# Merton Council Planning Applications Committee 9 February 2023 Supplementary agenda

#### **Modifications Sheet.**

#### ITEM 5 – 19 ARRAS AVENUE, MORDEN, SM4 6DG

PART SINGLE /PART TWO STOREY SIDE AND REAR EXTENSIONS, ROOF EXTENSIONS AND CONVERSION OF PROPERTY INTO 6 SELF-CONTAINED FLATS (2 X 3-BED, 1 X 2-BED, 3 X 1-BED/1-PERSON) WITH ASSOCIATED OUTSIDE AMBENTY SPACE AND REFUSE AND BICYCLE ENCLOSURES

PROPOSED BIN STORE DETAIL

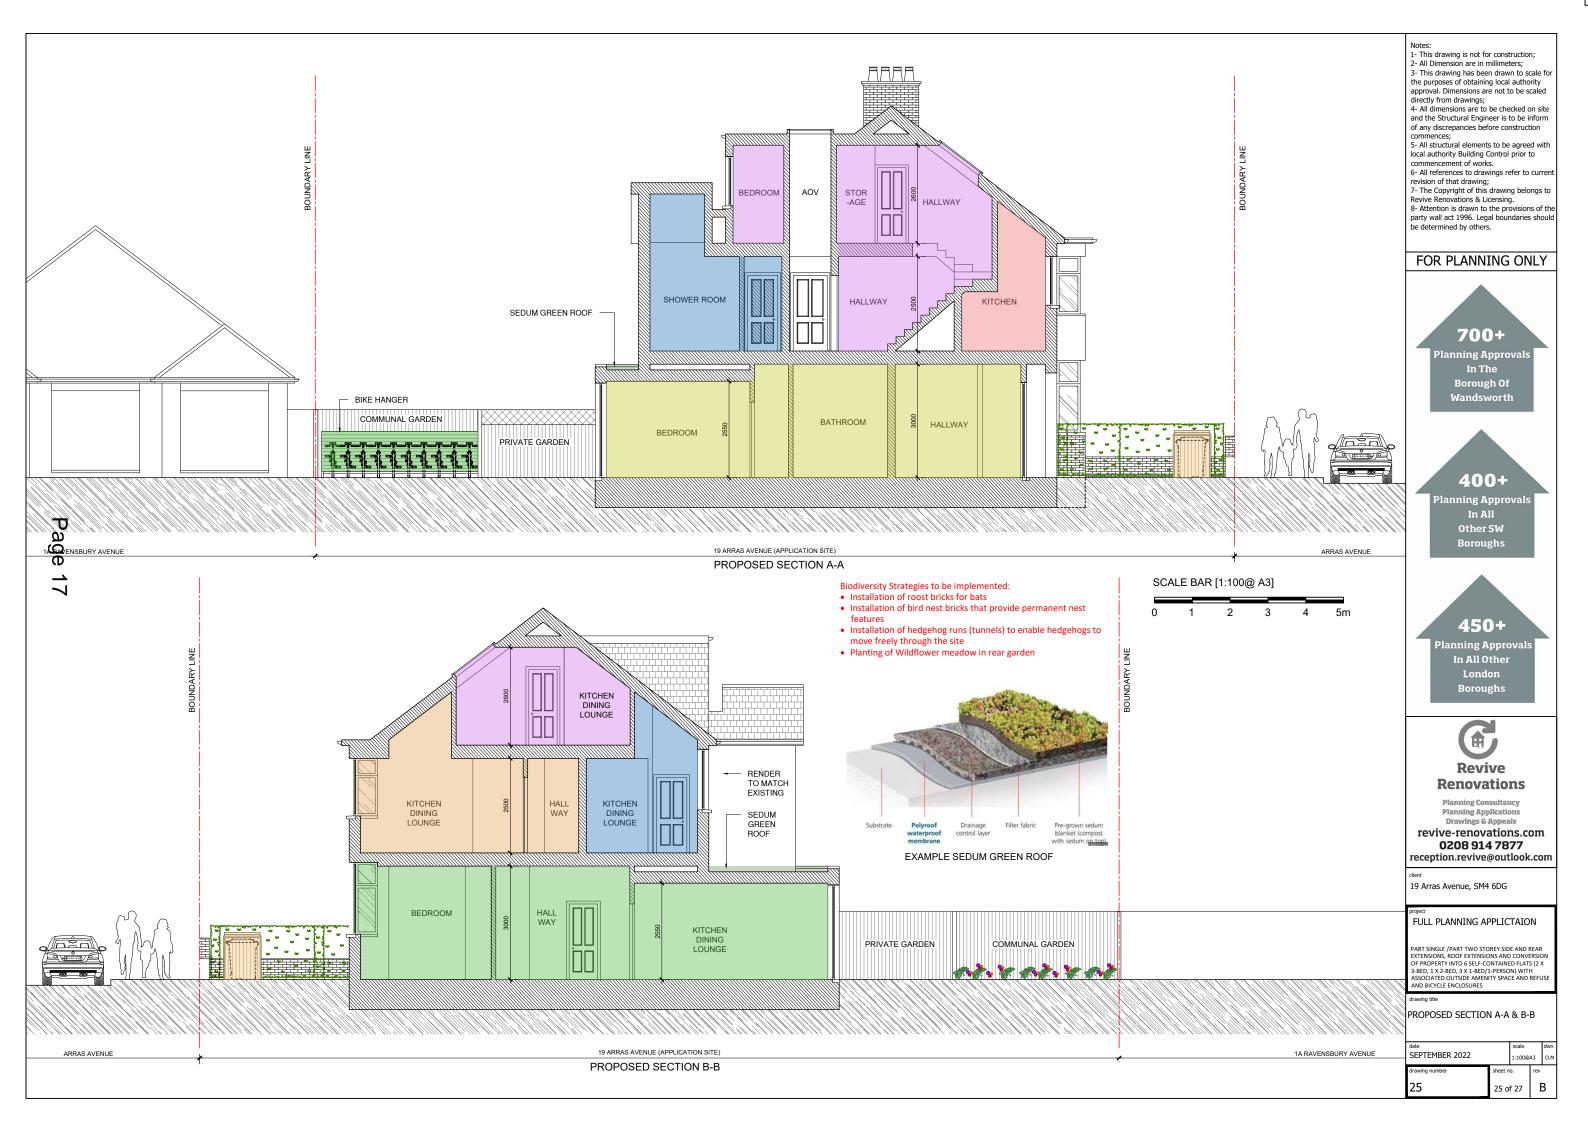
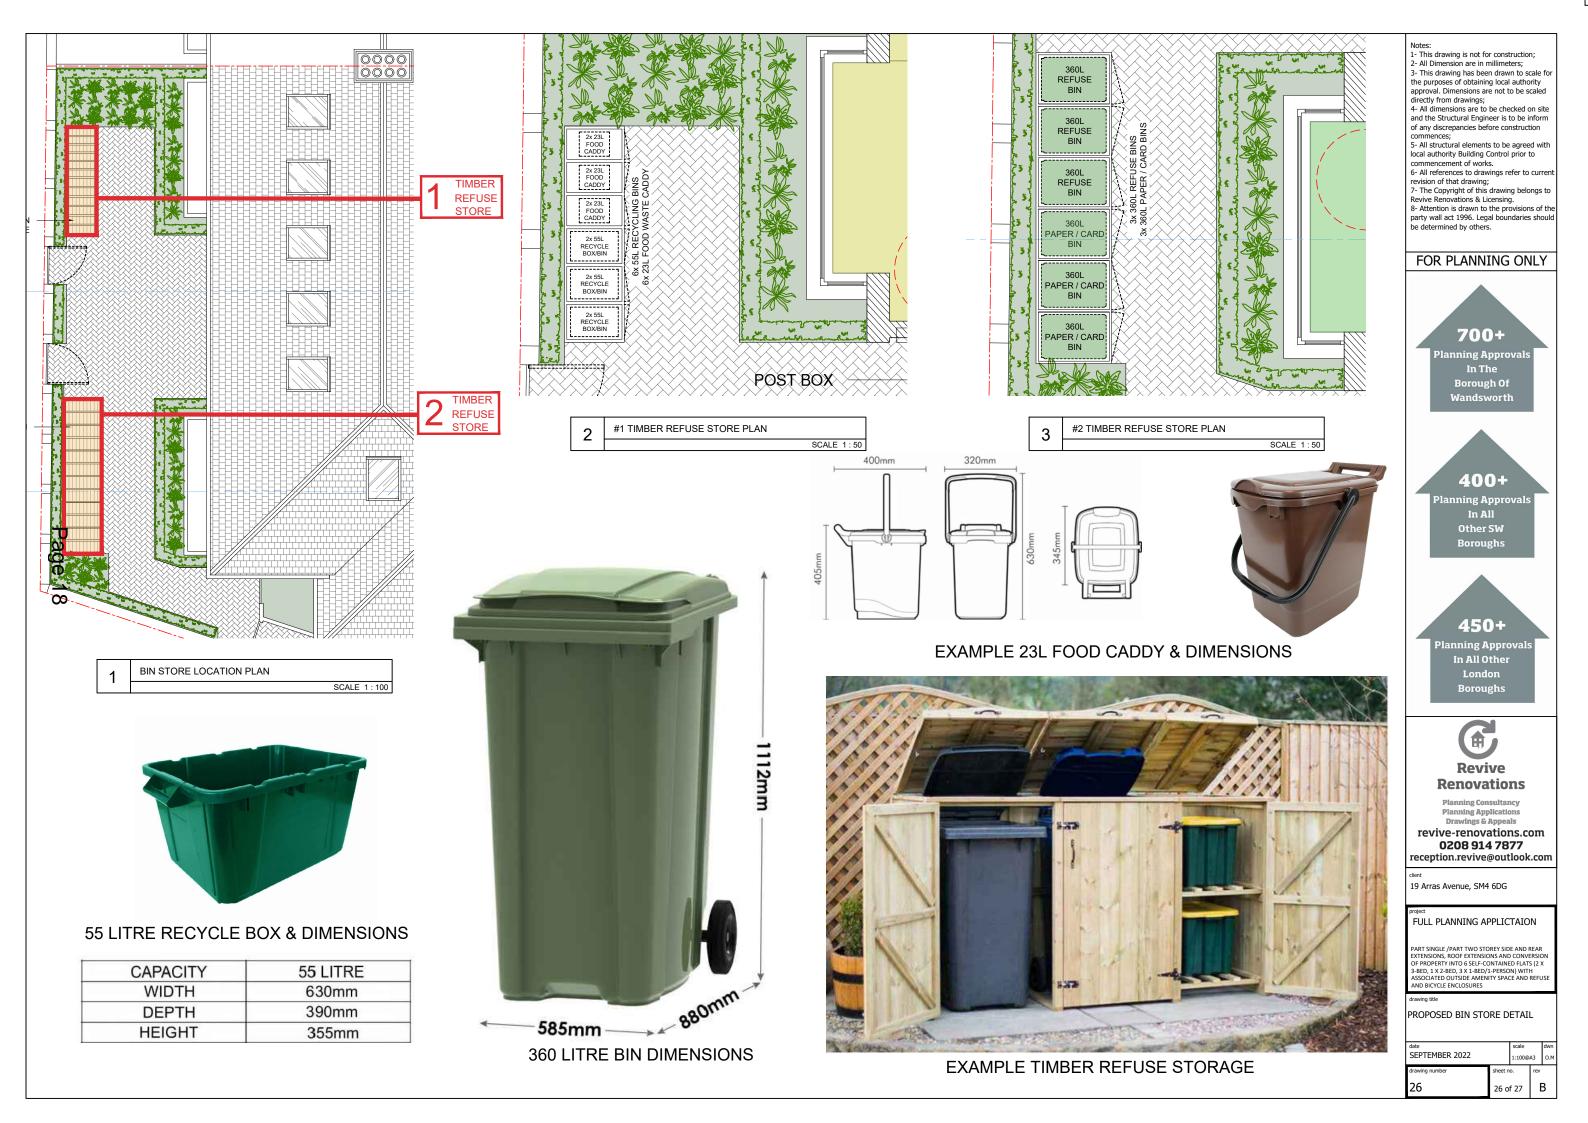
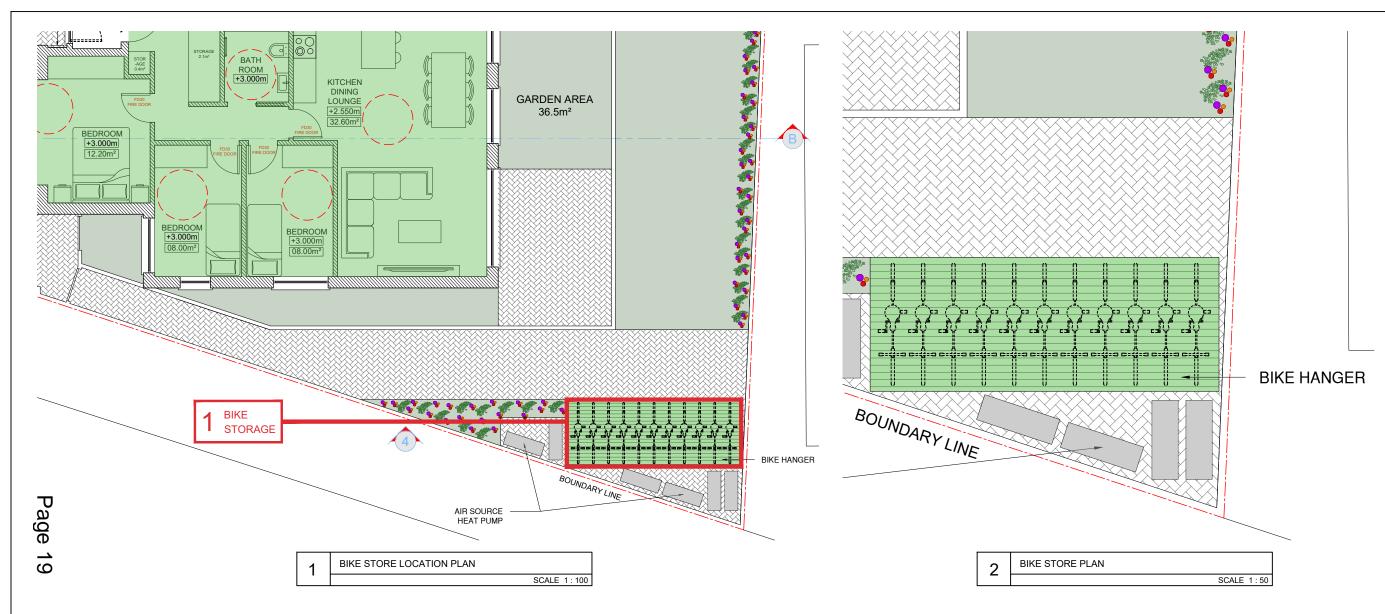
Following discussion with the applicant, amended drawings Rev B have been received (06.02.2023) showing biodiversity enhancements including;

- Installation of roost bricks for bats
- Installation of bird nest bricks that provide permanent nest features
- Installation of hedgehog runs (tunnels) to enable hedgehogs to move freely through the site
- Planting of Wildflower meadow in rear garden
- Inclusion of a green roof

18 Rev B, 19 Rev B, 20 Rev B, 21 Rev B, 22 Rev B, 23 Rev B, 24 Rev B, 25 Rev B, 26' BIKE STORE PLAN' Rev B, 26 'TIMBER REFUSE STORE PLAN' Rev B
